AMMONIA-UREA FERTILIZER COMPLEX AT NAMRUP, ASSAM
[NIT NO. PNMM/PC230/E/001 DATED 20.11.2025]

CORRIGENDUM-4 TECHNICAL (PROCESS) DATED 10.02.2026

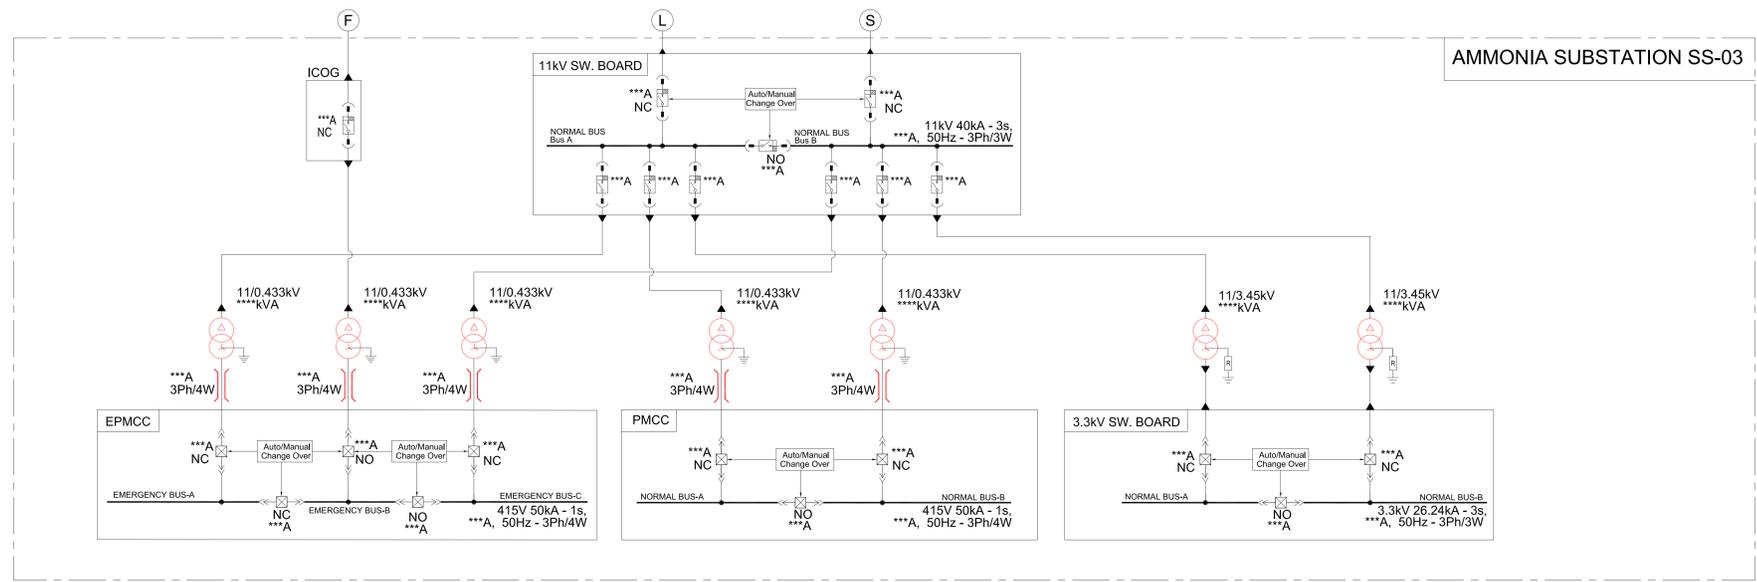
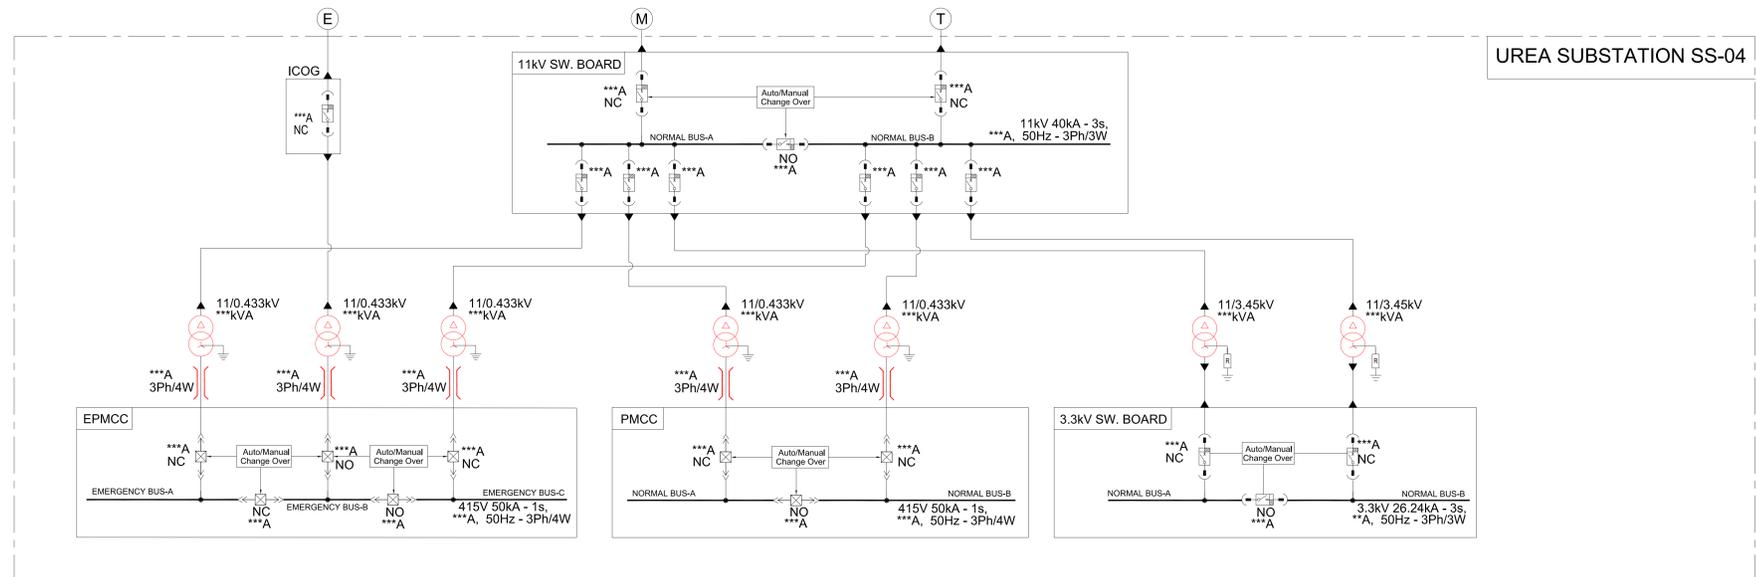
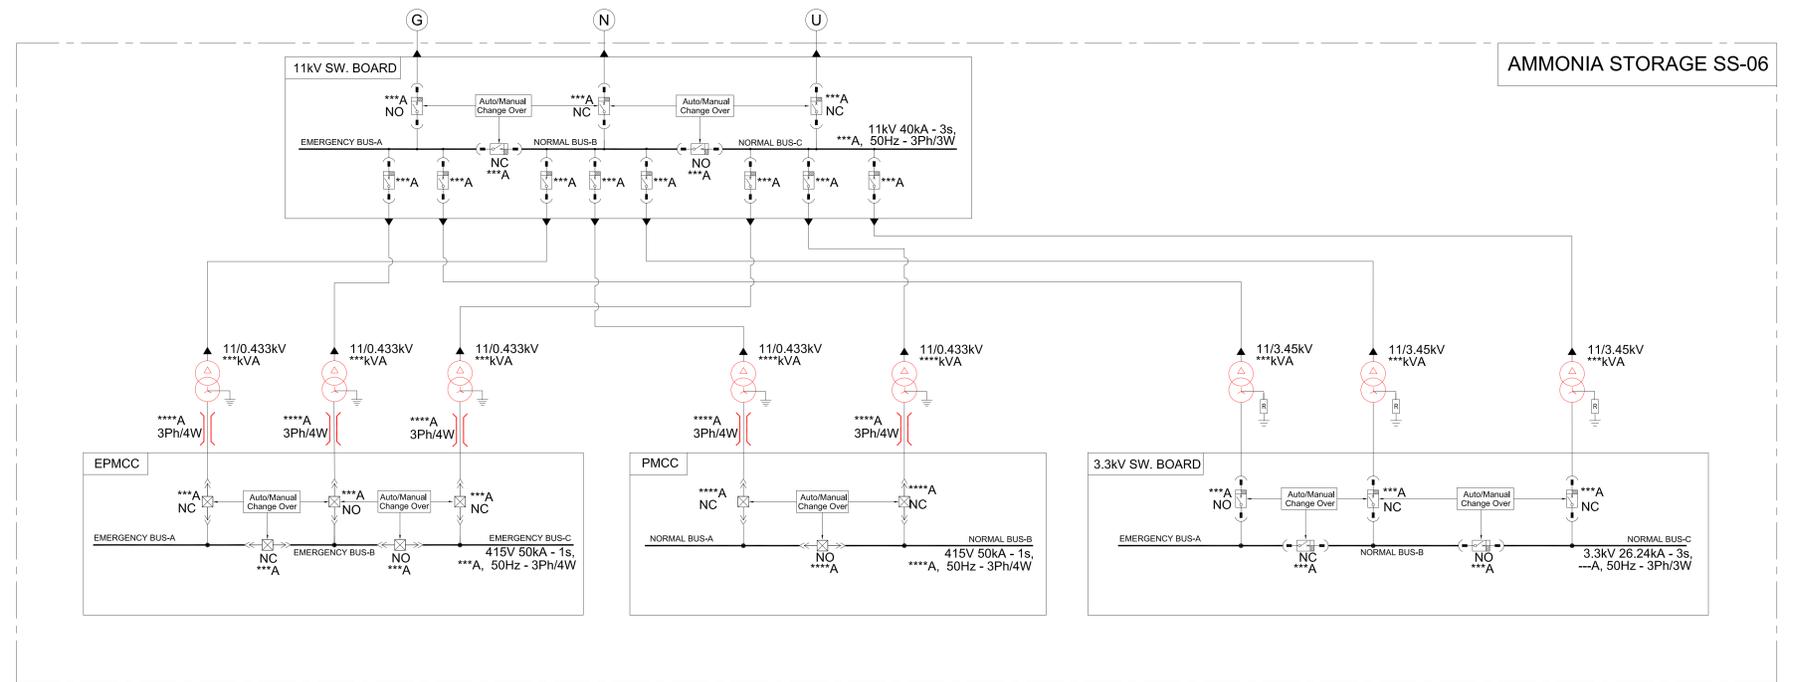
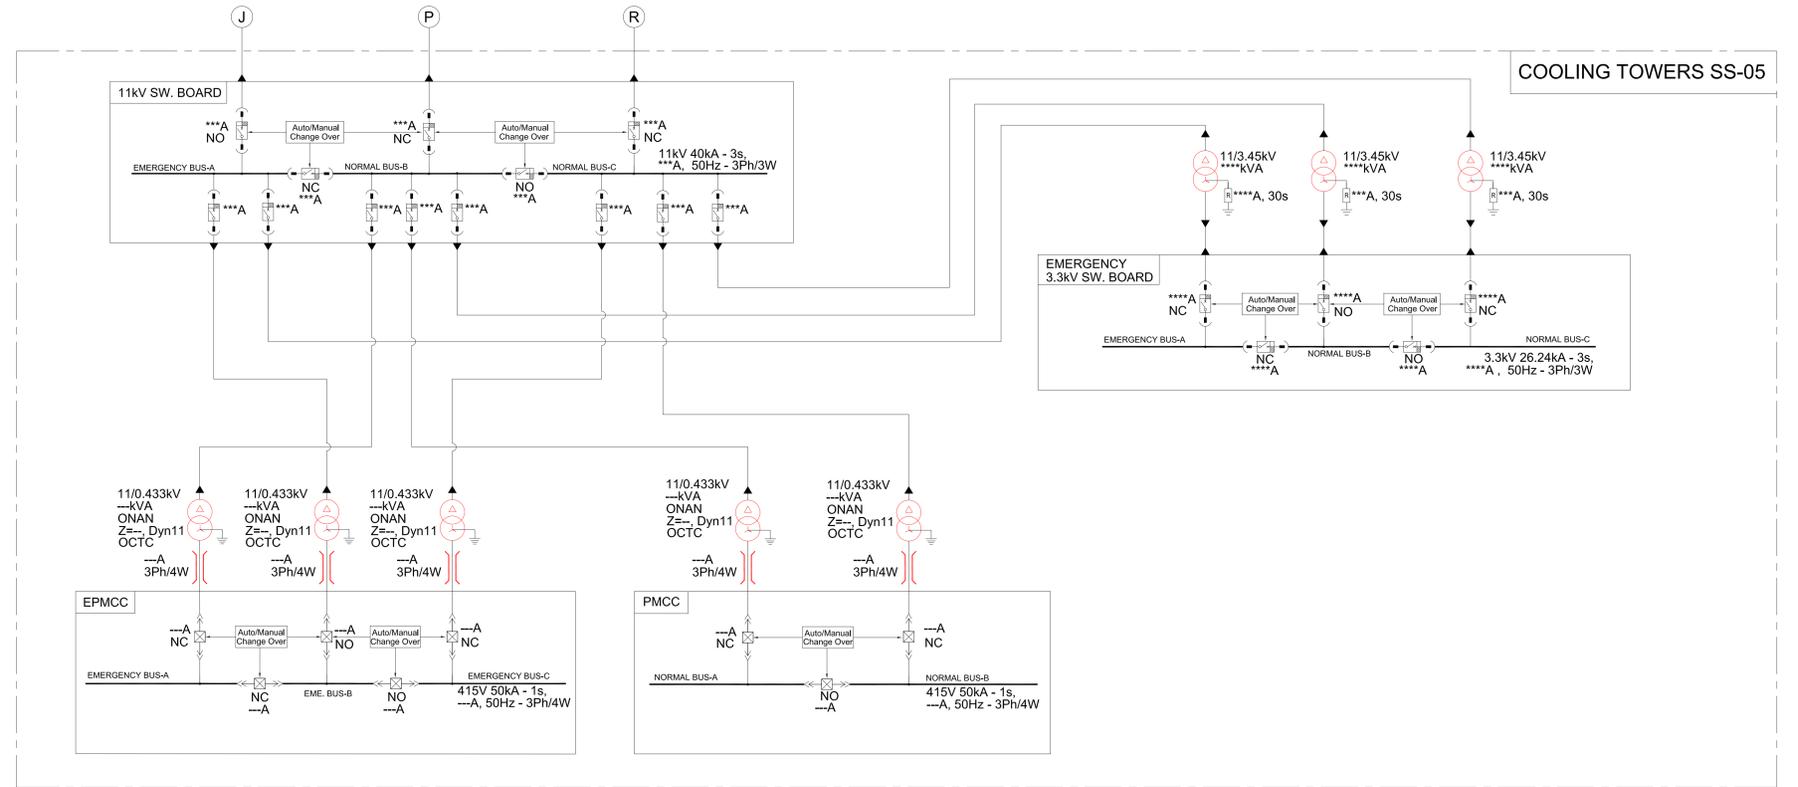
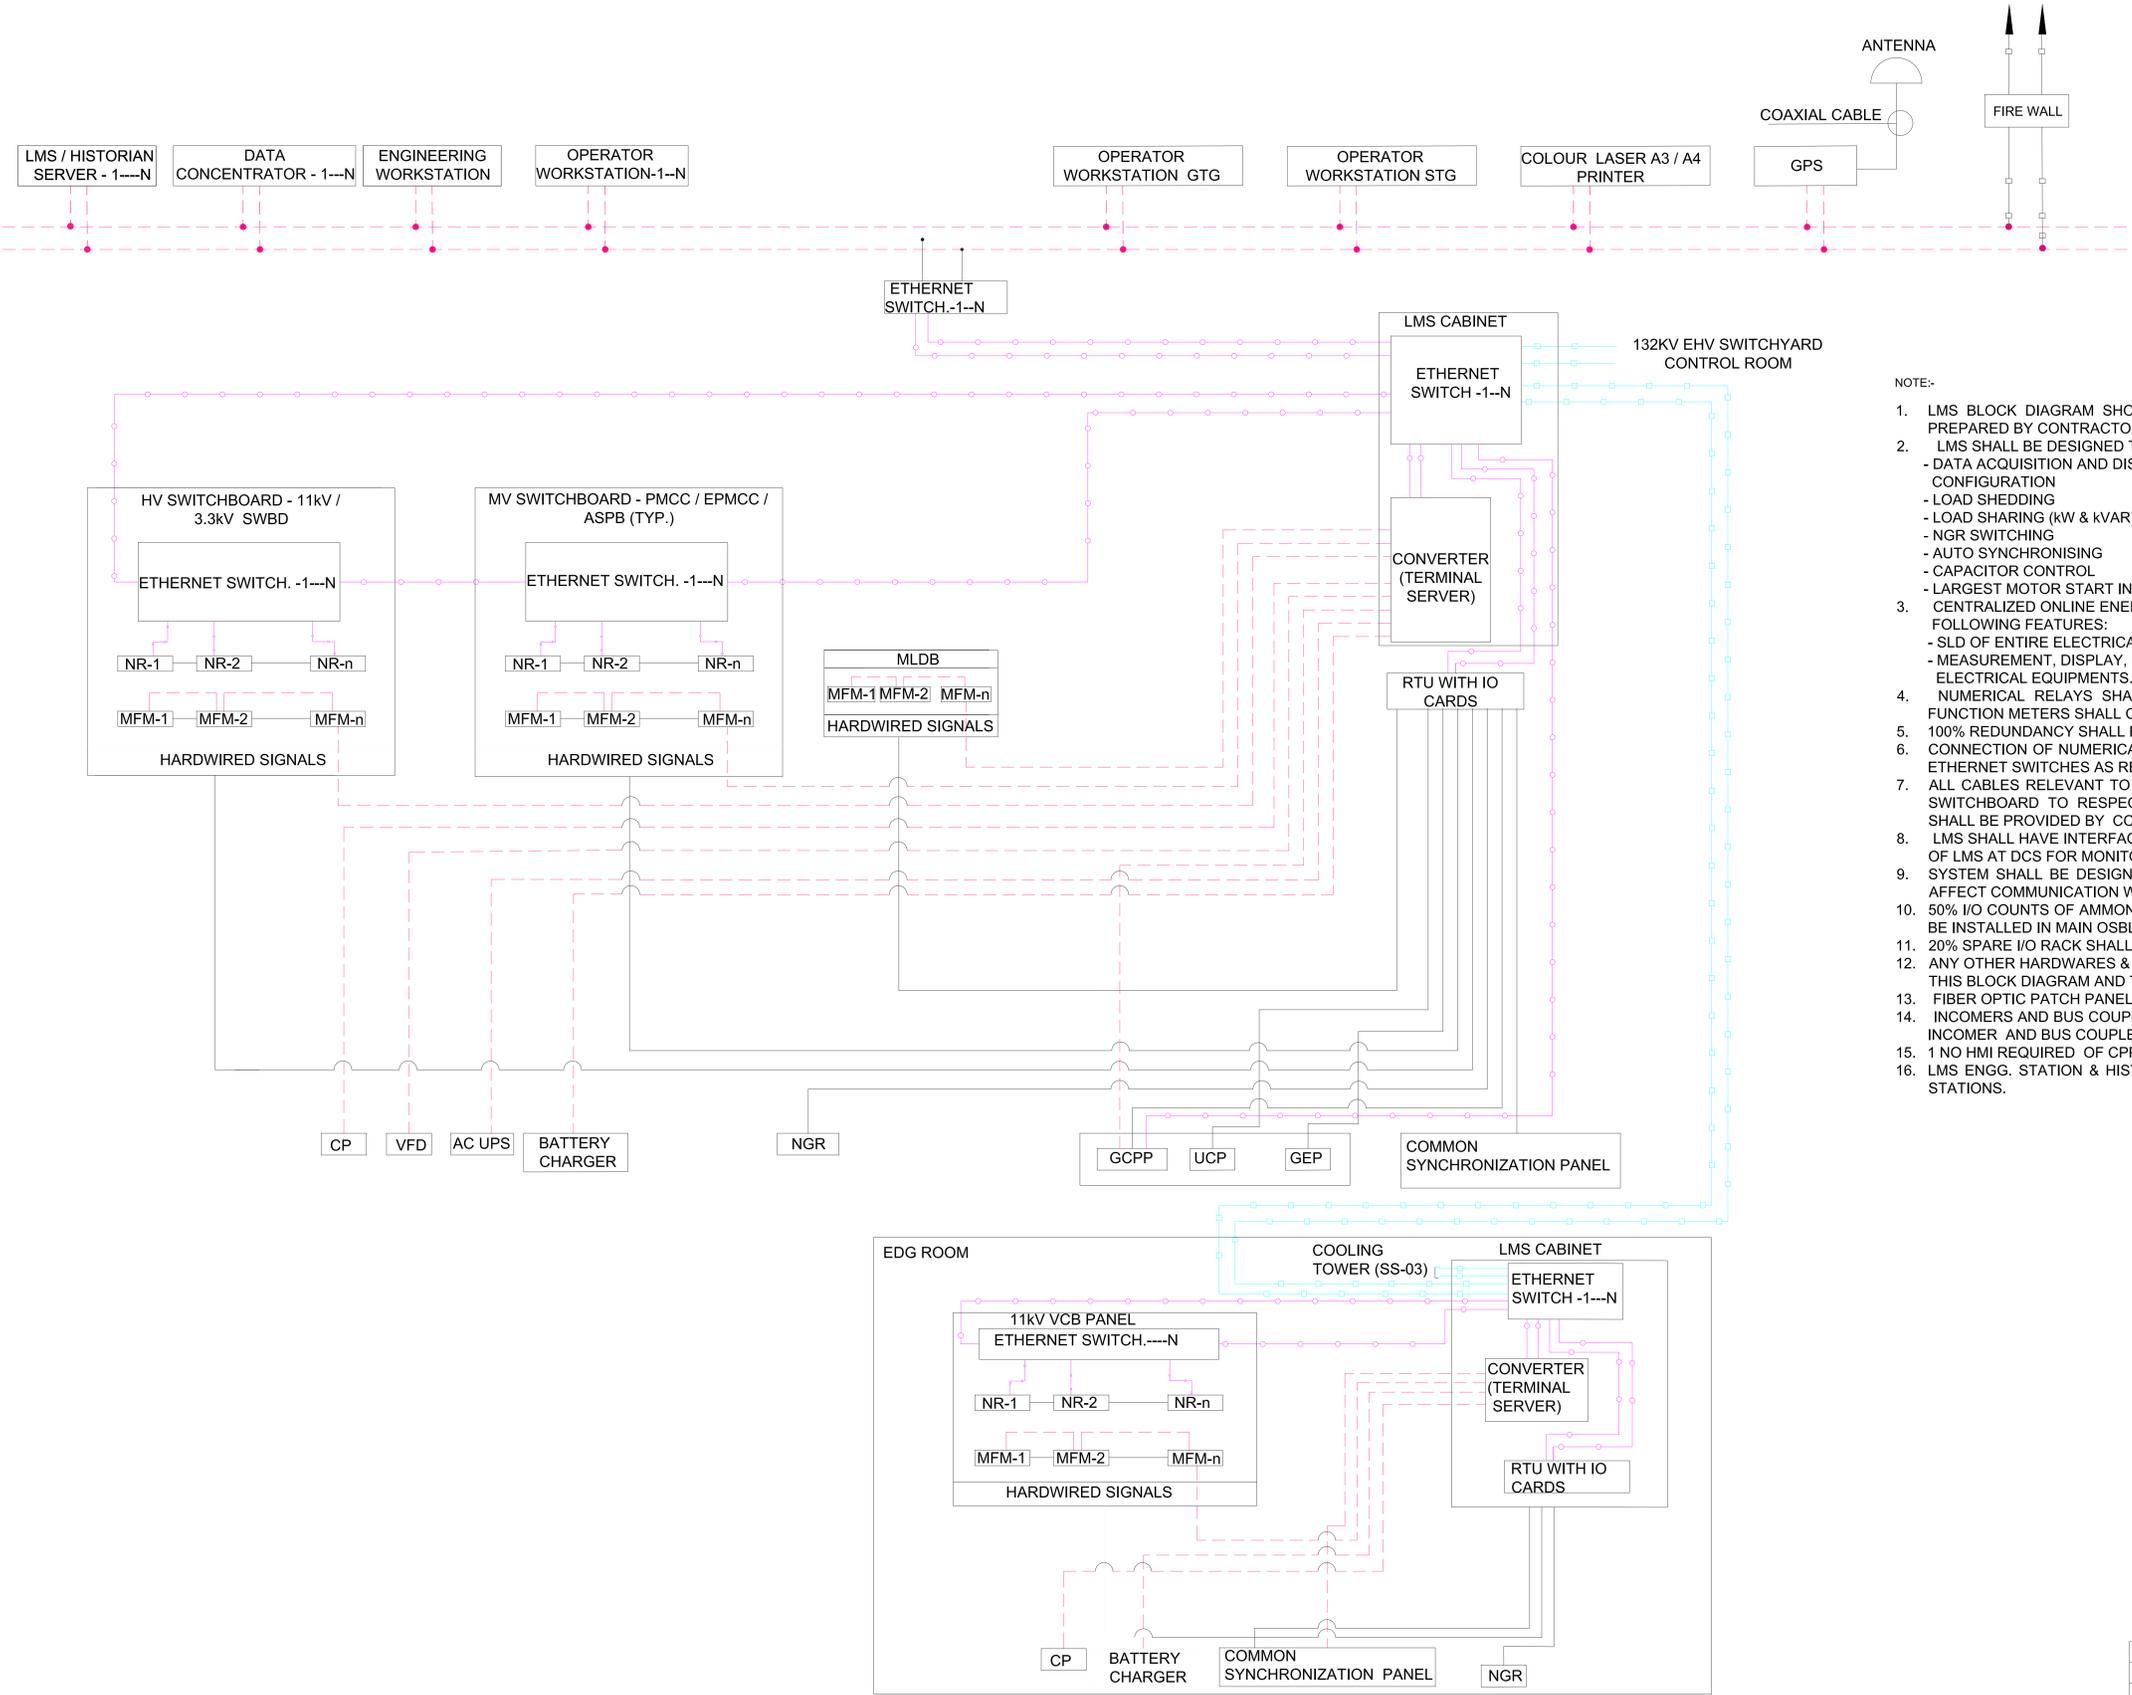
25.	SEC – 5.3 TS-8208	5 OF 11	5.1.3	owner’s	M	Read “owner’s” as “LSTK Contractor’s”
26.	SEC – 5.3	--	--	Key Single Line Diagram (PC230-7411-0985, Rev. 0)	M	Revised “Key Single Line Diagram (PC230-7411-0985, Rev. 1)”
